Lot 203
43 Macartney Street, York

SCHEME ASSESSMENT

DA No. P948

Proposal: Construction of a shed.

SITE PLAN

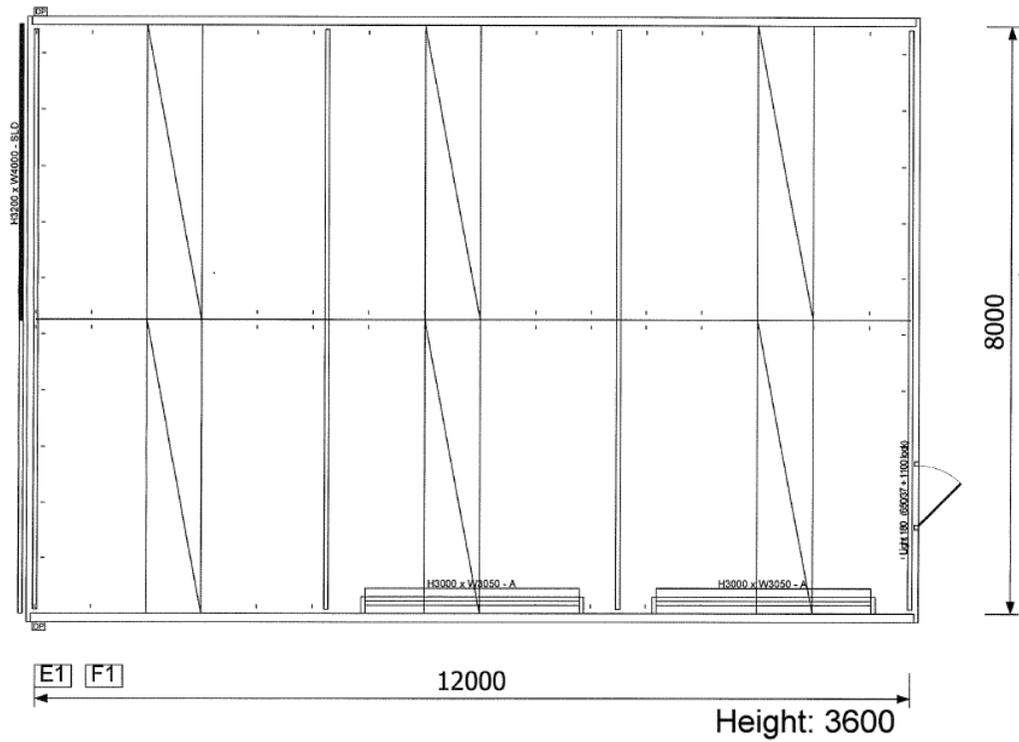
The objection from the neighbour included concerns regarding proximity to her boundary and the visual impact from her kitchen window as well as the potential to block light in this area.

The original proposal being 8m by 16m and located 2m from the property boundary and adjoining neighbour was considered to have a significant impact to the adjoining neighbour with relation to height, bulk and scale.

Based on Table 2a/2b of the R-Codes, a development with a wall height of 4.2m (rounded to 4.5) and a wall length of 12m, with no major openings, is only required to be 1.5m from the property boundary. As there are concerns with the property boundary and alignment (see below and further comments in (zb)) it was considered that an amended setback of 5m from the property boundary (approximately 4m from the fence) is considered adequate in this context.

Light – in relation to the shed potentially blocking light into the neighbouring property. An amended site plan indicating a minimum setback of 5m from the property boundary will still allow light into the dwelling.

However it this has been taken into consideration and as the setback is a minimum of 5m, it would mean the shed is approximately 4m from the adjoining fence, which is still considered acceptable.
